ADDENDUM NO. 2*Renovation Services for*
WELDON AUDITORIUMManning, South Carolina
Meadors Project No. 21-0024
Clarendon County Project No. ITB 2024-014**DATE OF ISSUE: March 21st, 2025****PREPARED BY:****ARCHITECT:**Meadors, Inc.
2811 Azalea Drive
Charleston SC, 29405
(843) 723-8585

This Addendum consists of TWELVE (12) pages, the following enclosures, and addresses the questions received to date:

a. RTHP-1:

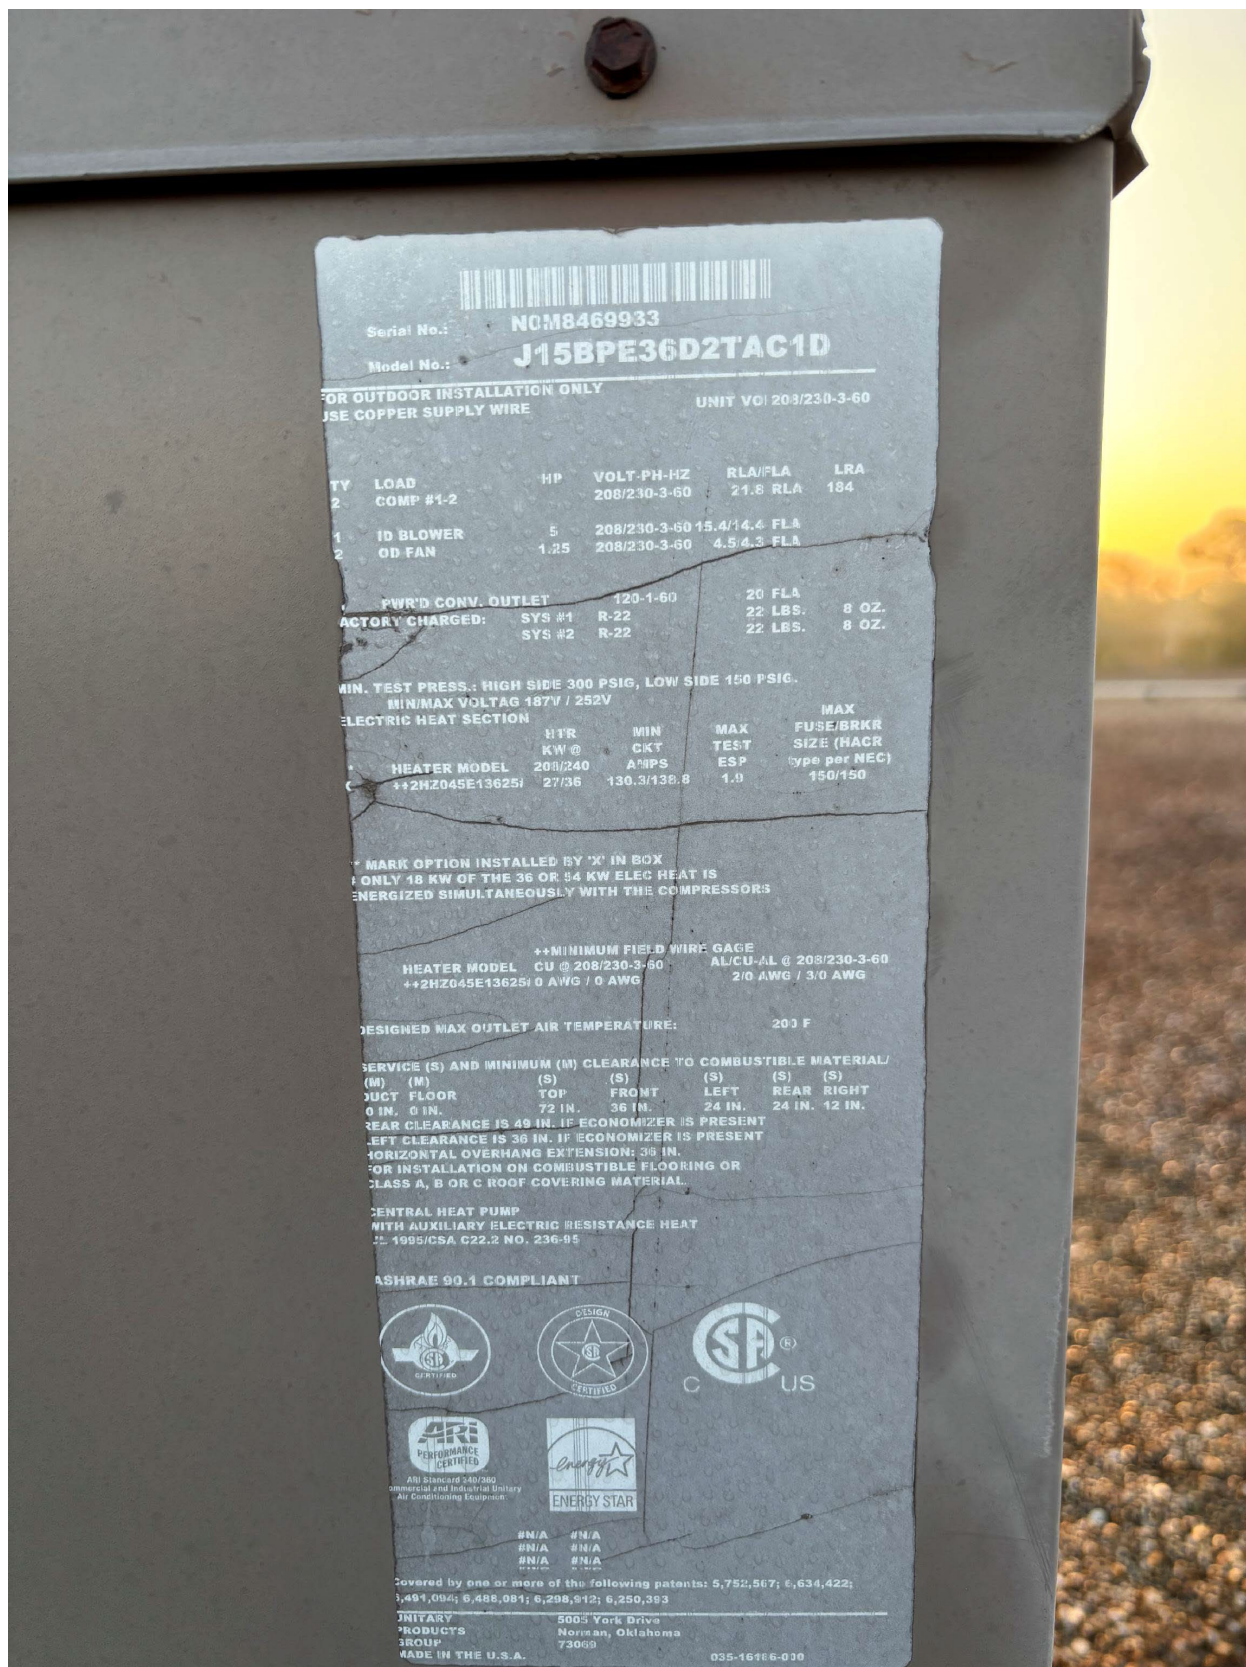
1. ITB General Questions
 - a. **Question:** Do you have the data plate info for the RTUs?
 - i. **Response:** Owner has requested that mini-split units CU-1 – CU-5 to be included in the base bid in kind replacement scope of work. Mini-split units CU-1 – CU-5 are to be removed and install new equally compliant units. Available data plate photos are provided below for all units selected to be removed and new equally compliant units to be installed. Refer to sheets M1 & M2 in the Bid Drawing packet for the corresponding units.

M1

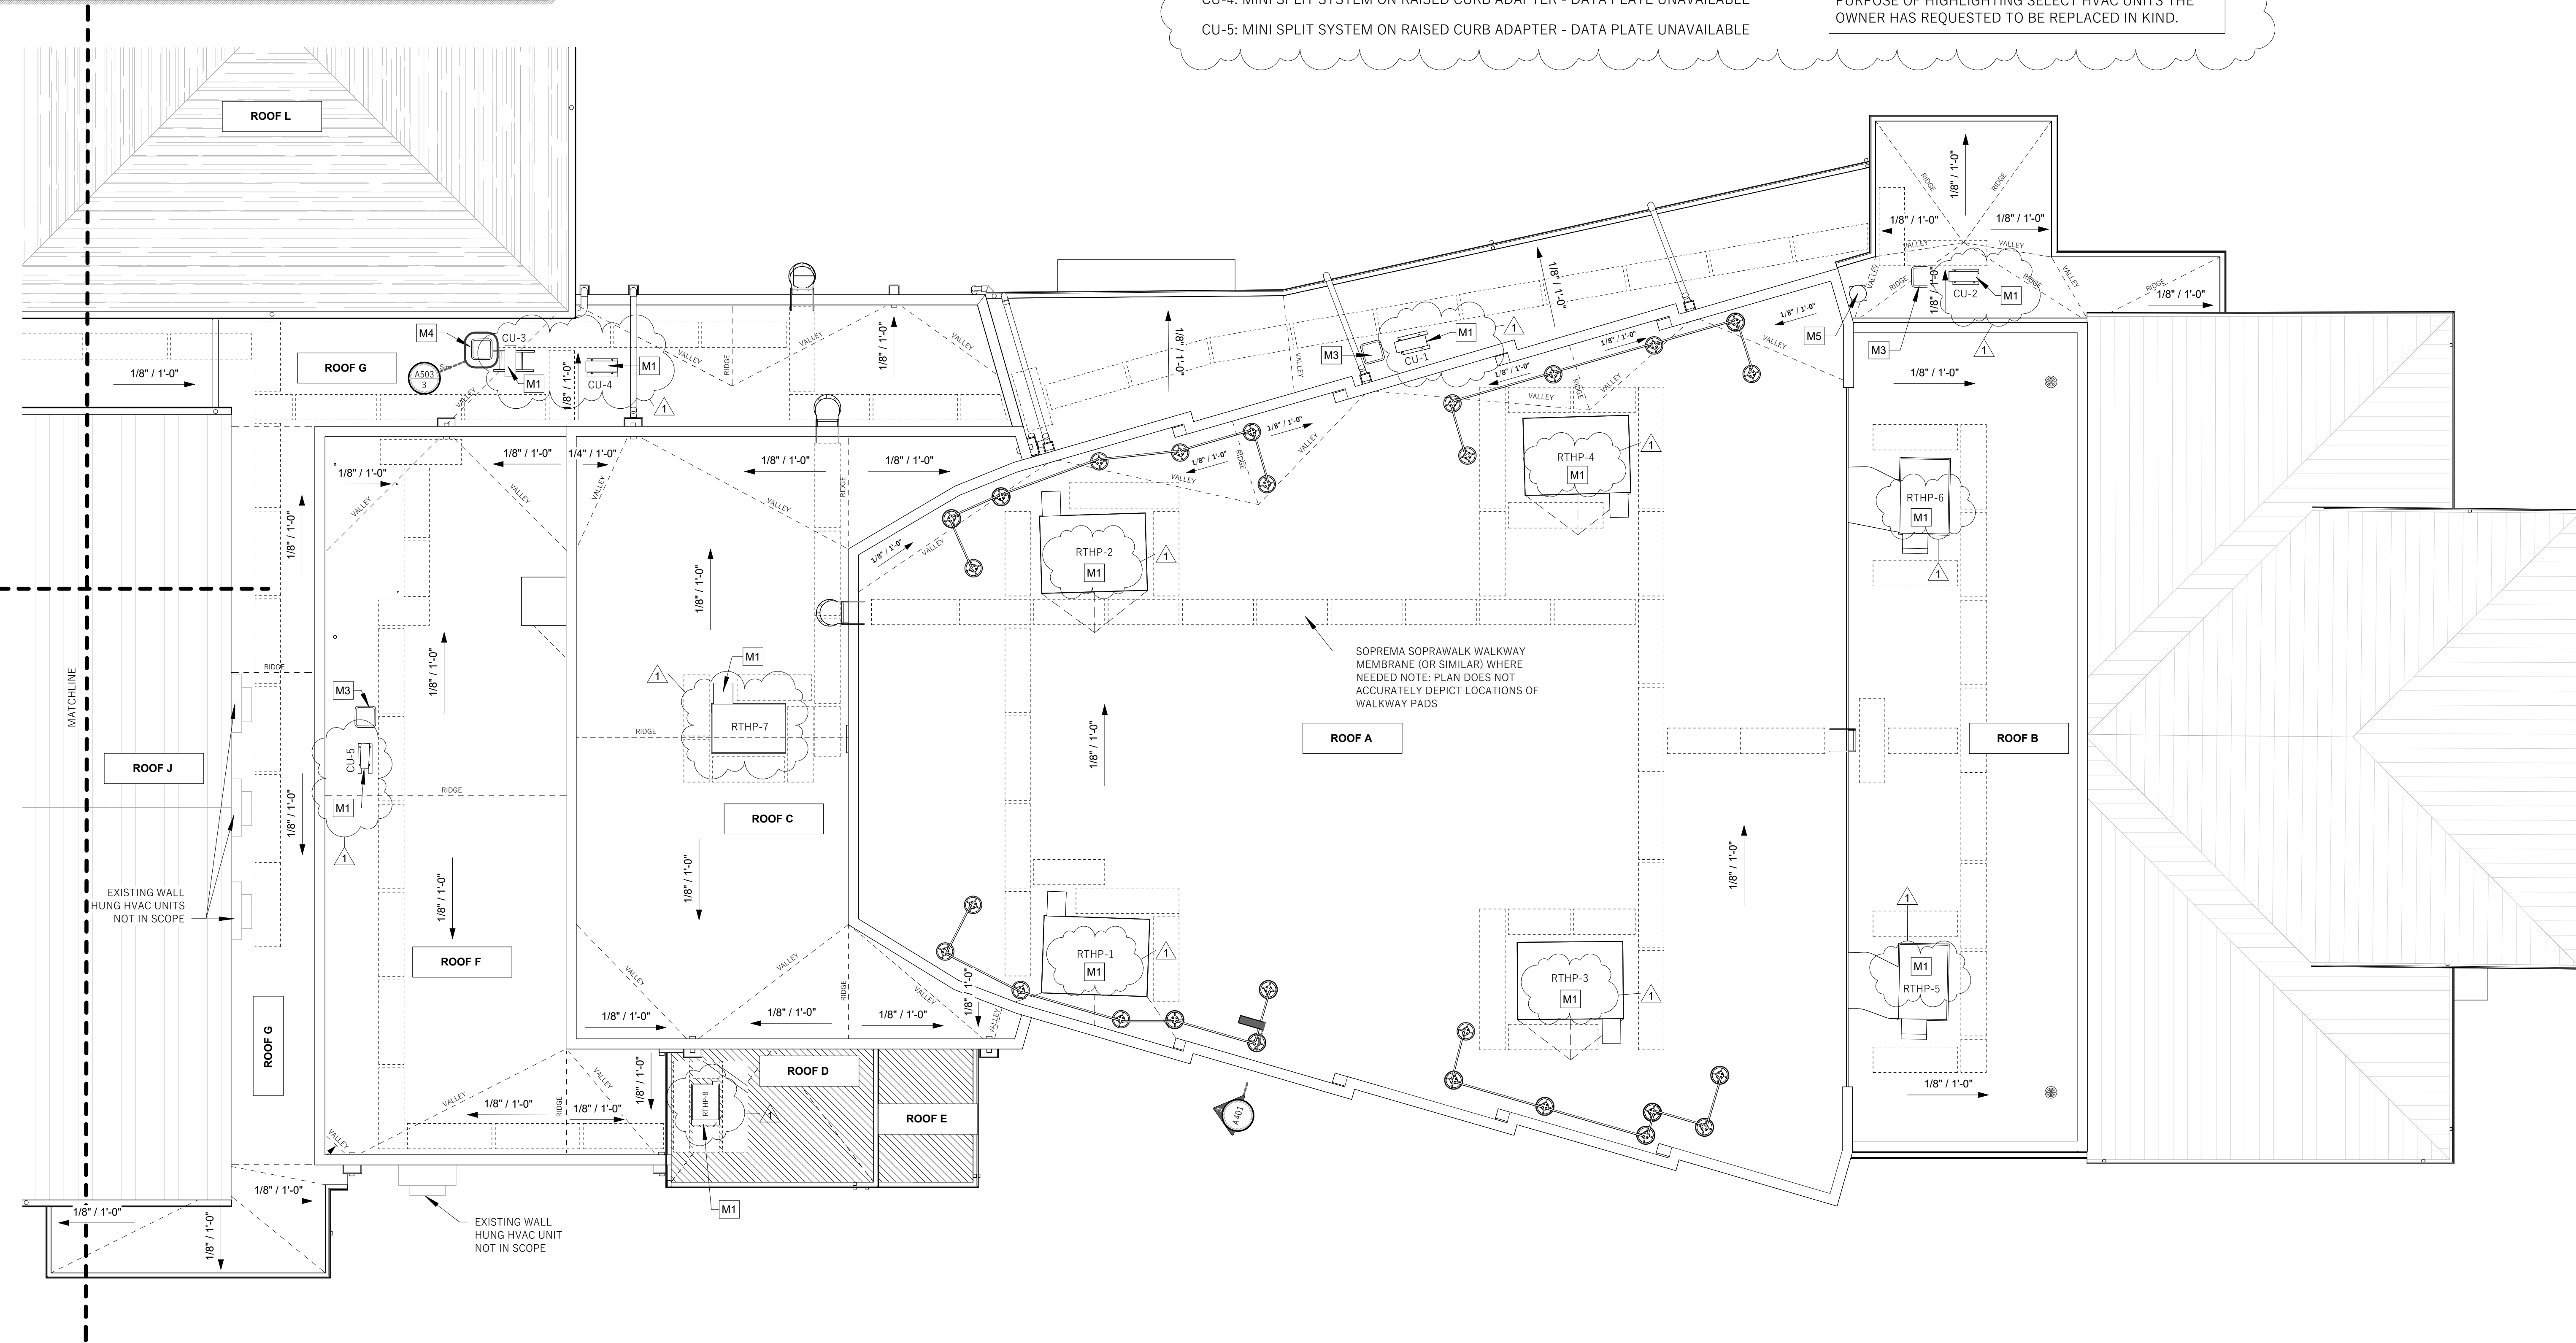
- d. **Question:** Without information regarding the existing units and in order to match for new units at this late date, it might be difficult to price by bid date.

- i. **Response:** A mechanical engineer was not hired for this project so there are no M sheets stamped by a licensed engineer. Owner has requested that mini-split units CU-1 – CU-5 to be included in the base bid in kind replacement scope of work. Mini-split units CU-1 – CU-5 are to be removed and install new equally compliant units. Available data plate photos are provided above for all units selected to be removed and new units to be installed. Refer to sheets M1 & M2 in the Bid Drawing packet for the corresponding units.
